CHRYSLER 42RE, 44RE, 46RE, 47RE

ANOTHER GOVERNOR PRESSURE SENSOR AND SOLENOID ASSEMBLY HARNESS DESIGN CHANGE

01-32 Page 1 of 8

Figure 1

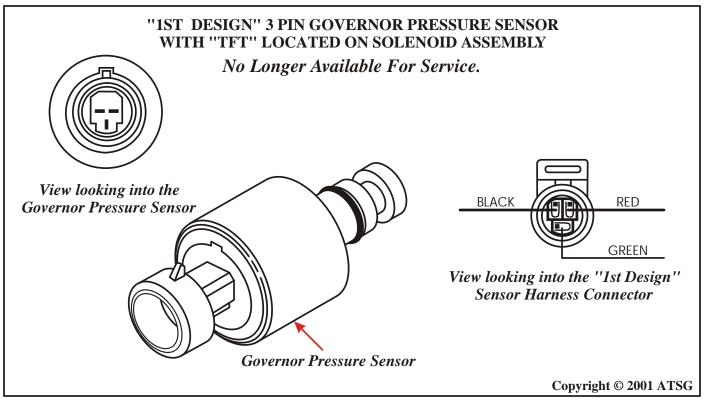
Originally, the Governor Pressure Sensor/Transducer was a 3 terminal sensor, with the Transmission Fluid Temperature (TFT) Sensor mounted on the Overdrive/TCC Solenoid.

The original 3 wire sensor is illustrated in Figure 1, and the wiring schematic for these models is shown in Figure 5.

Figure 2

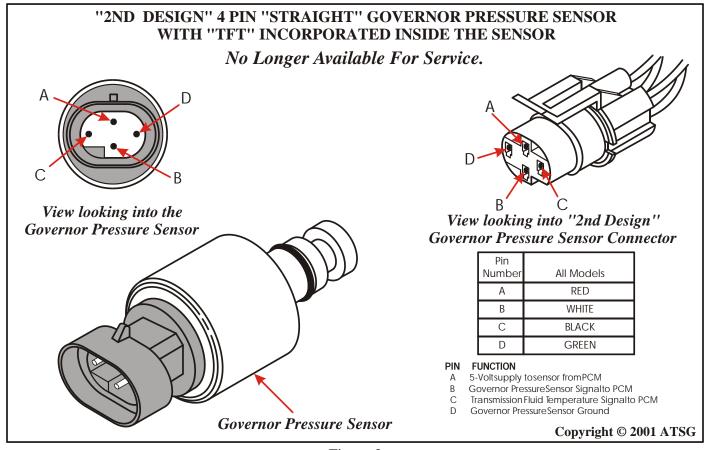
Beginning at the start of production for all 1996 models, Chrysler incorporated the externally mounted TFT sensor into a new design governor sensor, which required a fourth pin to be added to the new sensor. This also necessitated an internal harness change, to accommodate the redesigned 4 terminal governor sensor.

Reason: - Increased Transmission Fluid Temperature Sensor accuracy for improved reliability and durability.

The 2nd design 4 wire sensor is illustrated in Figure 2, and the wiring schematic for these models is shown in Figure 6. Each terminal in the new sensor has been identified with the letters A, B, C and D, as shown in Figures 2 and 6.

2nd Design Level - Will retro-fit back on all models, but requires the upgraded internal harness and solenoid assembly. This one also is not recommended and is no longer available.

Figure 3

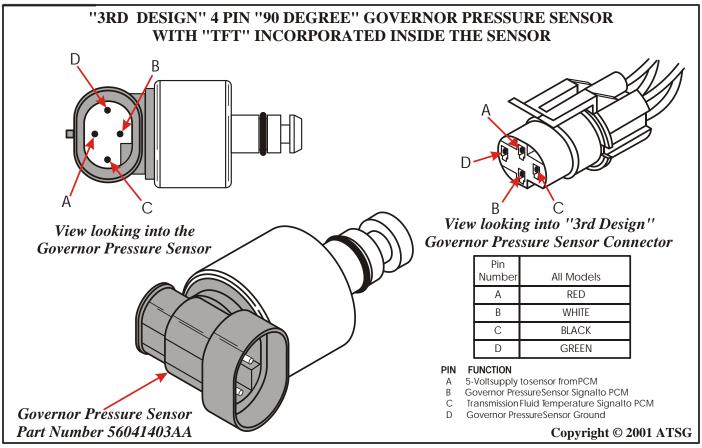
Late in the 1996 model year, Chrysler again changed the connector on the governor pressure sensor, from the previous straight, to a 90 degree connector. This change however, did not require a new internal harness and solenoid assembly.

Reason: - Relieved the stress on the internal harness connector, and once again improved reliability and durability.

The 3rd design 4 wire, 90 degree sensor is illustrated in Figure 3, and the wiring schematic for these models is shown in Figure 6. Each terminal in the new sensor has been identified with the letters A, B, C and D, as shown in Figures 2 and 6.

3rd Design Level - Will retro-fit back on all models, but requires the upgraded internal harness and solenoid assembly, part number 52118500, as shown below.

Figure 4

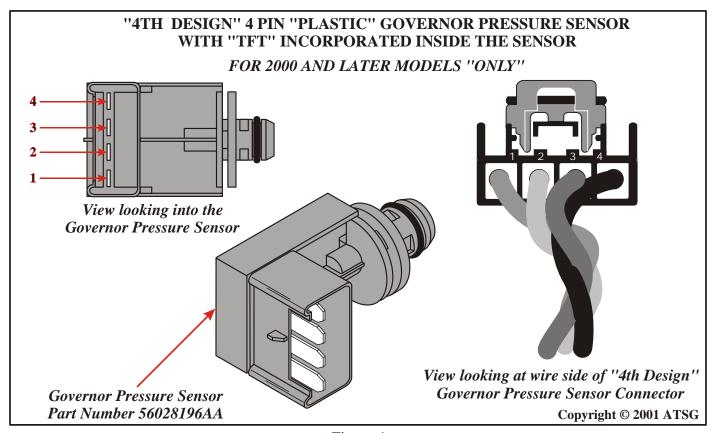
During the 2000 model year, Chrysler Corporation introduced another new governor pressure sensor (transducer), as a running change, which also required another new internal wiring harness, to accommodate the new sensor. The 4th design governor sensor is made of plastic and has four larger "spade" type terminals, transmits a different signal, has a redesigned connector and a shorter snout where it goes into the adapter body.

Reason: - More cost effective because of the material, and the shorter snout allows a much improved flow of governor oil to the sensor, for greatly improved accuracy and reliability. Refer to Figure 8 for illustrations of 3rd and 4th design sensors in the adapter housing.

The 4th design 4 wire, 90 degree sensor is illustrated in Figure 4, and the wiring schematic for these models is shown in Figure 7. Each terminal in the new sensor has been identified with the numbers 1, 2, 3 and 4, as shown in Figures 4 and 7. The 4th design level is illustrated mounted on the valve body in Figure 8. There is also a new design retainer that is required for the 4th design level parts and is illustrated in Figure 8.

4th Design Level - "Will Not" retro-fit back. The 4th design level, is for 2000 model year and later only, that are so equipped. Some 2000 models may be equipped with the 3rd design level parts. 3rd Design level parts must be used in 3rd design level vehicles, and 4th design level parts must be used in 4th design level vehicles. They will not interchange!
